Representations: Cost assessment

Document Reference: J003

This document contains U UW's representations on the Draft Determinations of the slow track and significant scrutiny water companies relating to cost assessment.

United Utilities Water Limited

Figure 1 Gap to the efficient totex allowance for cost sharing (£m). Proposed options; sourced FM_WW2_ST_DD & FM_WW4_ST_DD

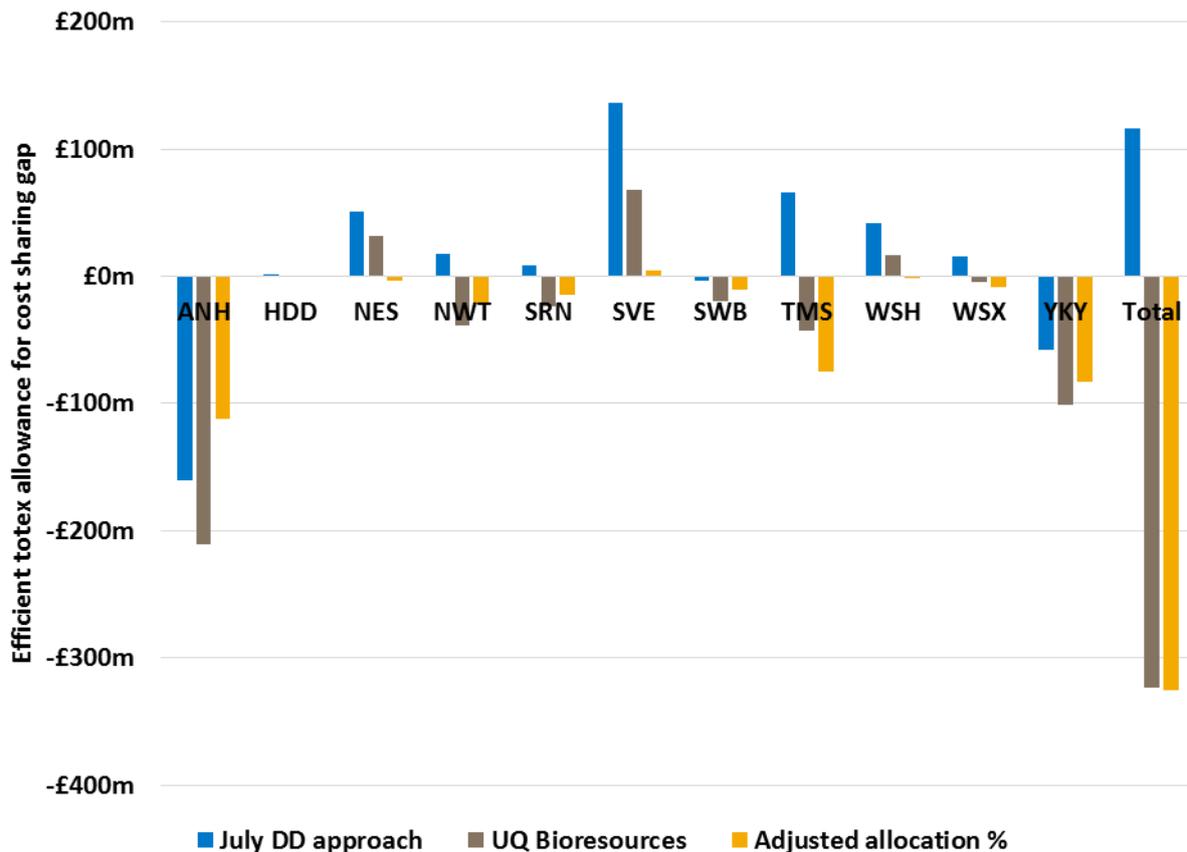
The different ‘efficient totex allowances for cost sharing’ generated for all companies are within Table 2 below and the resulting gaps to the business plan (Business plan totex excl. third party and PDRC, incl. G&C) for each company is illustrated in Figure 1. As Figure 1 and Table 2 show, the current approach to deriving efficient baselines for Bioresources (the blue bar in Figure 1) has resulted in an apparent “over allocation” of more than £100m across the industry (which results in significant windfall gains for some companies due the lack of cost sharing for Bioresources outperformance). Both alternative approaches result in approximately the same (lower) total expenditure allowance to the industry (c£2.5bn) for Bioresources – however, our proposed “adjusted allocation %” approach more significantly minimises the gaps to company business plans, as well as avoiding the aforementioned distortions caused by using an approach that ignores substitution effects (as is the case with the UQ Bioresources approach).

The problem that Ofwat faces is not just that Bioresources allowances do not appear sufficiently stretching, it is also that (comparatively) allocations based on modelled expenditure allowances are more susceptible to be biased, likely due to the impact of omitted variables in parsimonious models. In selecting the most appropriate approach, we have assessed each of the options available based on four key criteria:

Assessing against these four tests, our own analysis confirms that the most credible and robust solution to the issue with Bioresources cost assessment is through adopting the **Adjusted allocation % approach**. It ensures that the amount allowed within Bioresources is set at a more stretching level, maintains the aggregate wastewater efficiency challenge, allocates Wastewater expenditure more in line with the asset configuration (proxy by cost) between the two controls of the company and more closely correlates with company business plans giving a better idea of true efficiency. **This will also offer the greatest protection to customers across all companies, preventing them paying for a service that may not be required, in a control with no sharing expenditure mechanism.**

- Allocates between Wastewater Network plus and Bioresources based on the ‘proportion to bioresources’ weightings, consistent with the approach taken to Water Resources.
